AP 115N - 0200 - 2

**MARKER UNIT
(VIDEO MAP)
TYPE 30**

**GENERAL ORDERS AND
MODIFICATIONS**

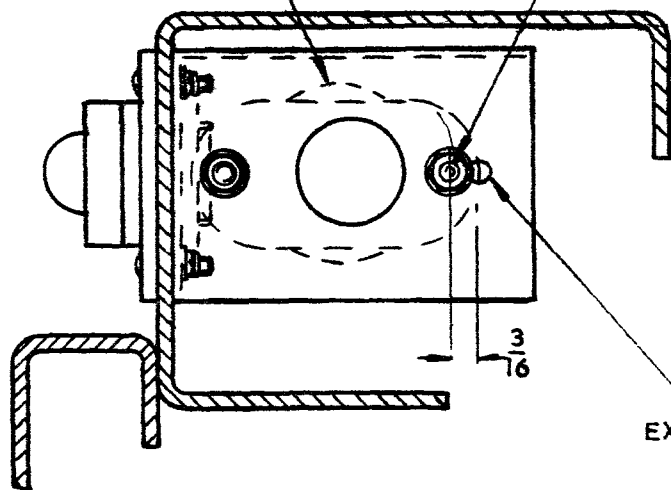
(4) Drill new 5/32" dia. fixing hole in Lampholder bracket as shown on the drawing. Remove swarf and treat raw edges with Varnish, Electrical Insulating Air Drying.

DRG. NO. AP2527R/B14/64

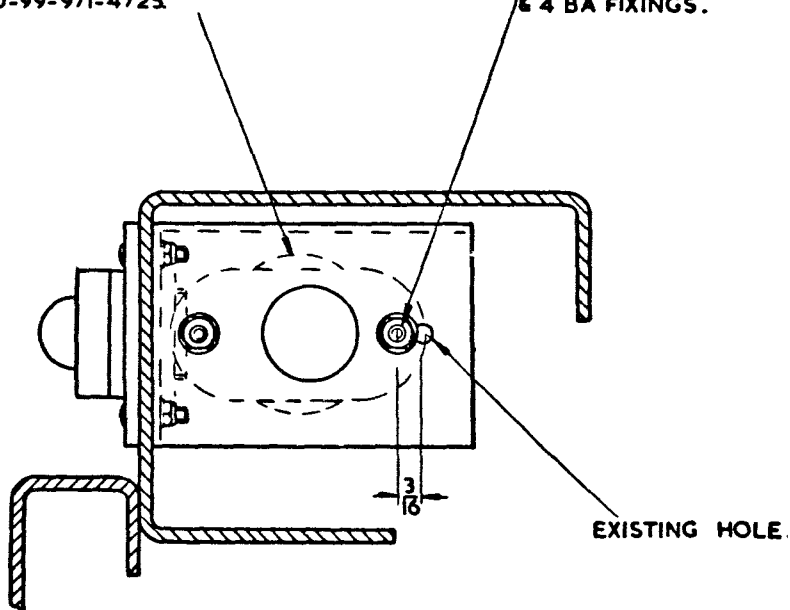
(4) Drill a new 5/32 in dia fixing hole in each lampholder bracket as shown on the drawing. Remove swarf and treat raw edges with Varnish Electrical Insulating Air Drying.

Drawing No. A.P.2527R/B.9/62

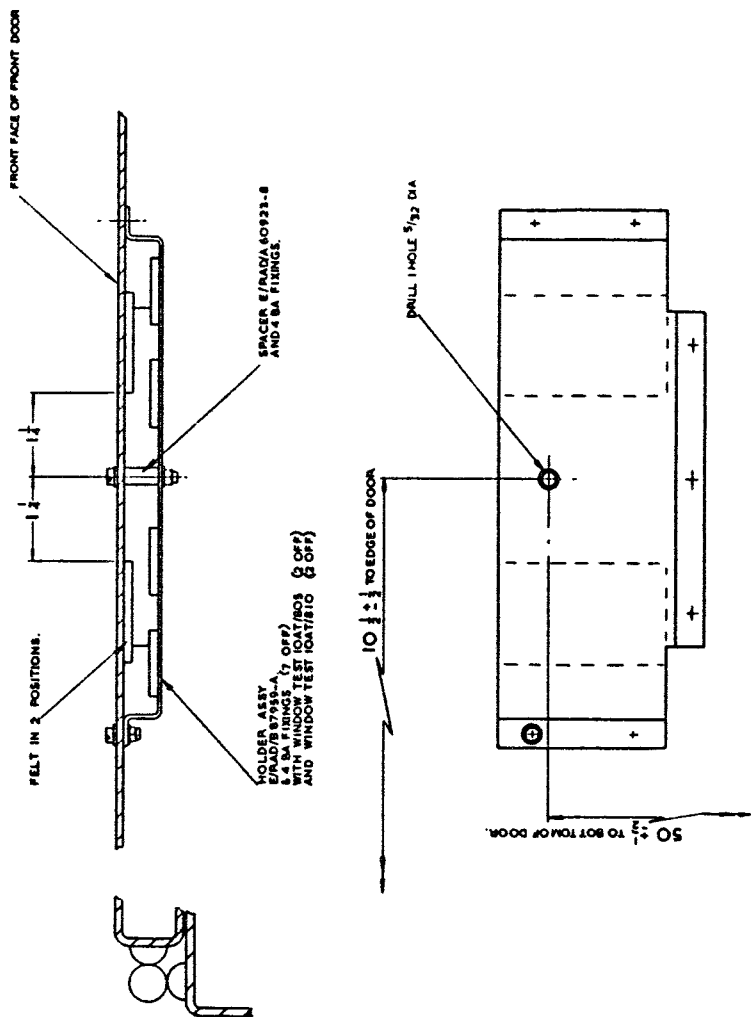
(2) At dimensions shown on the drawing drill 1 hole $\frac{5}{32}$ in. dia.

(3) Fit Holder Assembly, Part No. E/RAD/87959-A and Spacer, Part No. E/RAD/60923-8 and secure temporarily. Ensure that top of holder is horizontal. Using holder assembly as jig, drill seven holes through door using $\frac{5}{32}$ in. drill. Remove holder, de-burr holes and varnish raw edges.

(4) Using Adhesive (Ref. No. 33C/9436957) secure the two felt pads in position as shown on the drawing.

DRG. NO. AP2527R/38/62

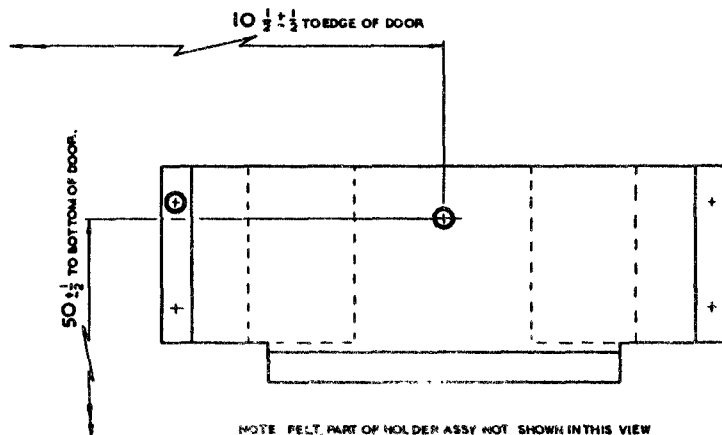
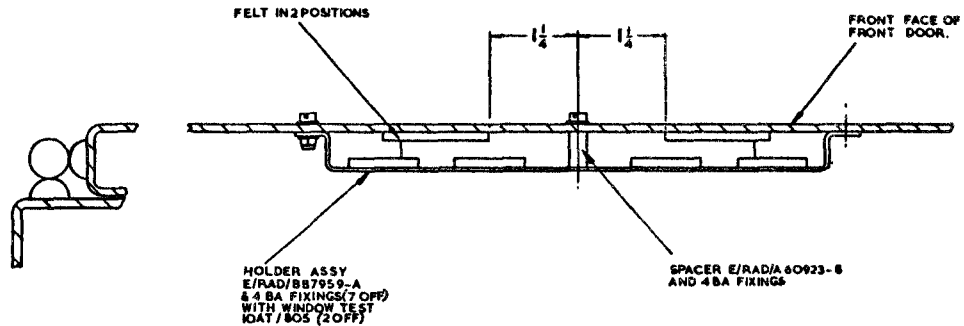
- (1) Open front door of Marker Unit (Video Map) 30 (Ref. No. 10D/18541), i.e., door which gives access to Indicating Unit 33, and lift door off hinges taking care not to loose spacing washers from hinge pins.
- (2) At dimensions shown on the drawing drill one hole 5/32 in. diameter.
- (3) Fit Holder Assembly W/RAD/87959-A and Spacer E/RAD/60903-8 and secure temporarily. Ensure that top of holder is horizontal. Using Holder assembly as jig, drill seven holes through door using 5/32 in. drill. Remove holder, de-burr holes and varnish raw edges.
- (4) Using Adhesive (Ref. No. 33C/9436957) secure in position as shown on the drawing the two felt pads.

- (5) Fit Holder Assembly E/RAD/B.87959-A and Spacer E/RAD/60923-8 and secure with 4 B.A. fixing material supplied.
- (6) Stow in holder assembly, two Window Test (Ref. No. 10AT/805) until required for use.
- (7) On completion of this modification delete the figure '1' from the unit modification record label.

DRG. NO A.P. 2527 R / B. 3 / 55

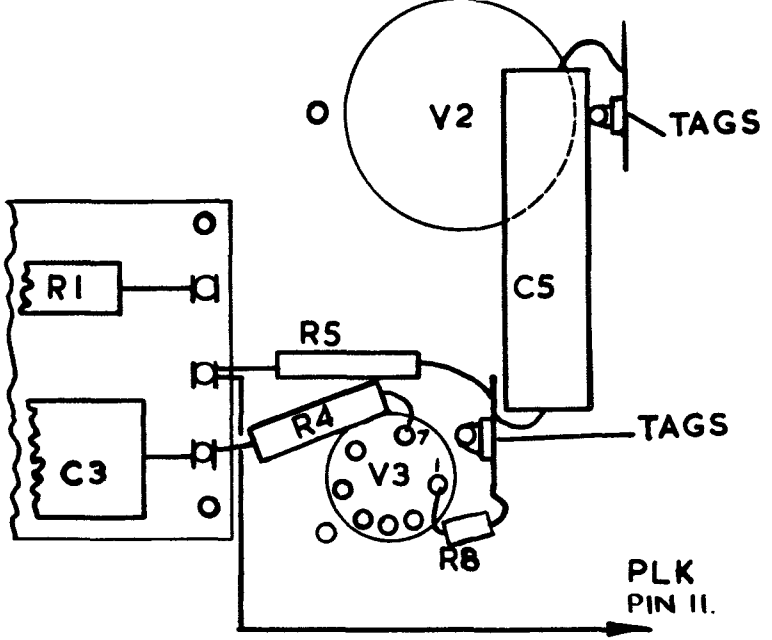
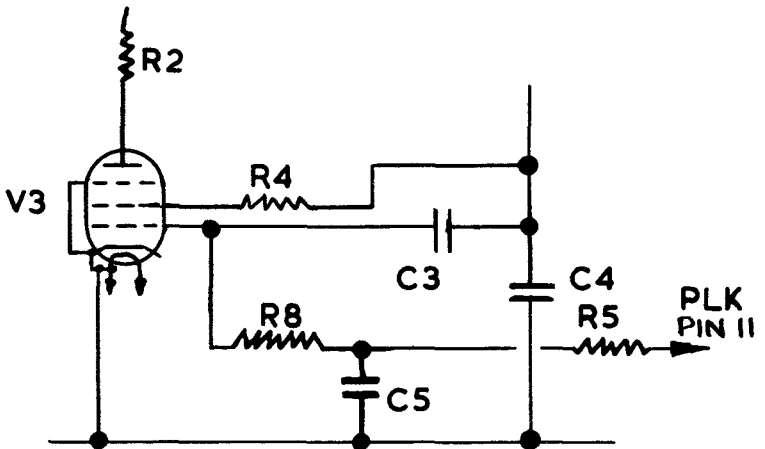
(1) Mount the two stand-off tags provided, one using the fixings of valve base V2 and the other using the fixings of valve base V3 as shown in the drawing.

(2) Disconnect resistor R5 from pin 1 of valve V3 and connect to tag as shown in the drawing.

(3) Connect the resistor R8, between pin 1 of valve V3 and tag, and the condenser C5 between the two tags as shown in the drawing.
